## SERVICE BULLETIN

**MACHINE OR VEHICLE AFFECTED:** TF Model MEWPs

**RISK IDENTIFIED:** Structural Cracks in Main Boom Rest

**DESCRIPTION:** Structural cracks can occur in the lower part of the main boom rest

TOP DOUBLER PLATE

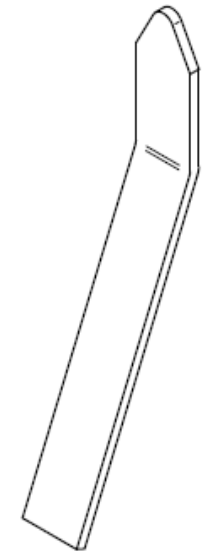
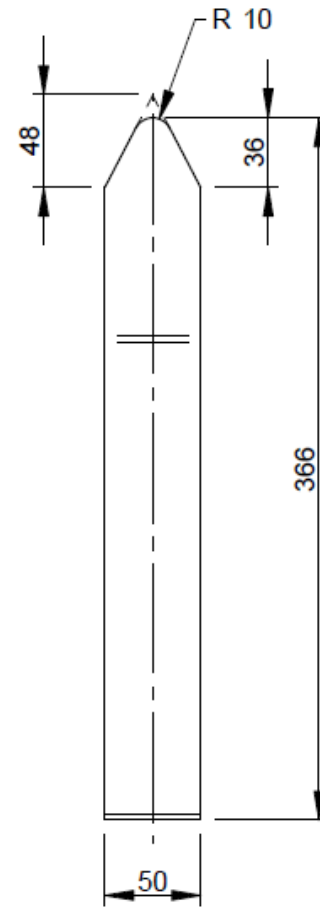
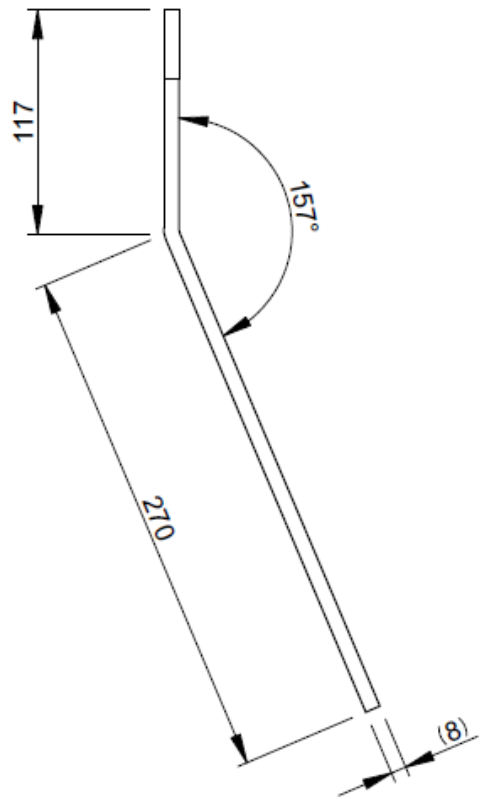
NOTE: SOME TRIMMING MAY BE REQUIRED

5. Make 2x Top doubler plates and 2x Bottom gussets. Drawings can be found on pages 3 & 4.
6. Weld in all 4 additional plates in accordance with the assembly drawing (page 2).
  - a. The electrical cable on the RHS must be well protected during welding to avoid damage.
7. Once cool, re-paint all exposed surfaces.

**BOTTOM GUSSET**

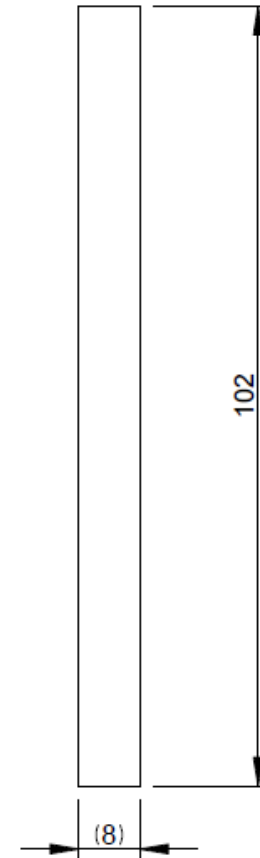
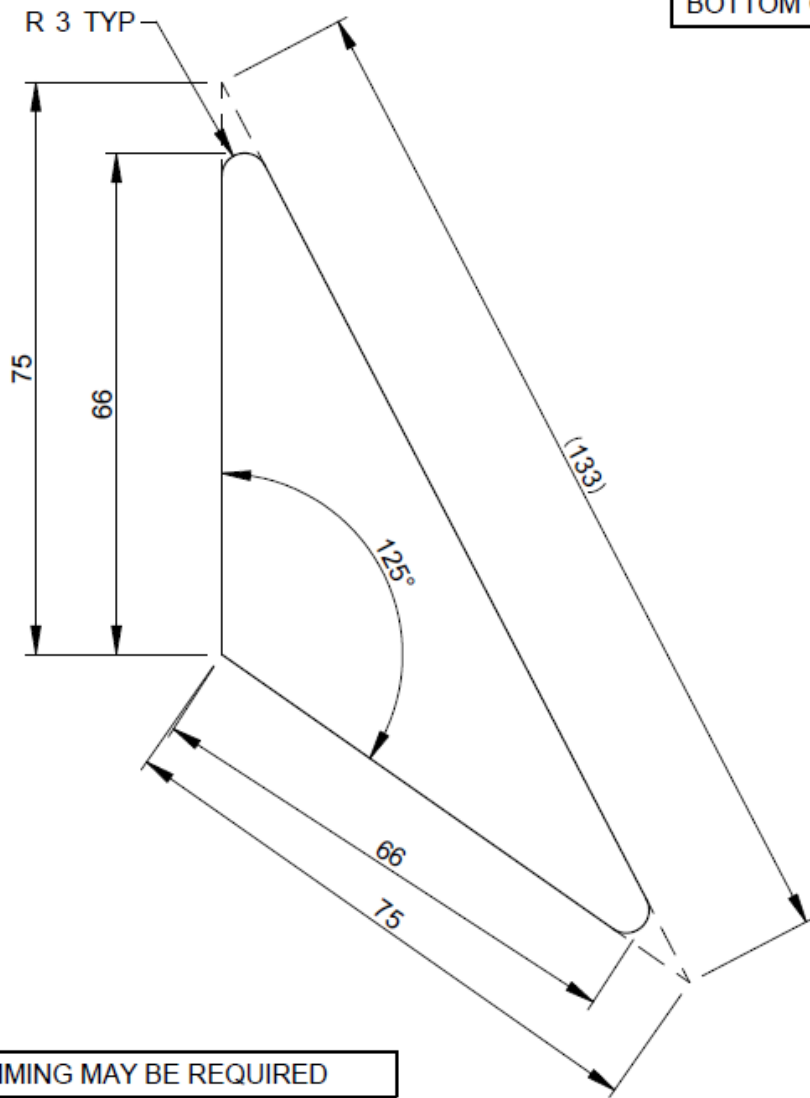
NOTE: SOME TRIMMING MAY BE REQUIRED
